Subject: Re-notification of DA 2020/0431 Pittwater Road Collaroy

Re: Submission to DA 2020/0431 4 Storey Mixed Use Building (2 commercial units & a boarding house) at 1129-1131 Pittwater Road, Collaroy

Photo 1 View of 1-5 Collaroy Street Adjoining the Rear Boundary of the Development Site

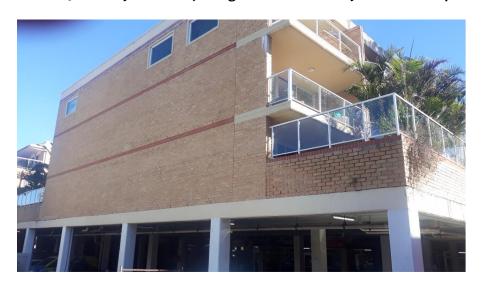
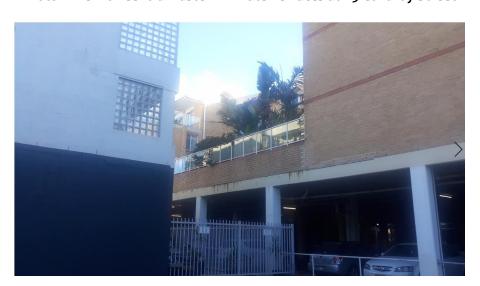
Photo 1, below shows the northeast portion of our client's building, as viewed looking southwest from the development site. In this location our client's building is located along the rear western boundary of the development site. Unit 44 and the east facing windows of this Unit are shown at the top of the photo.
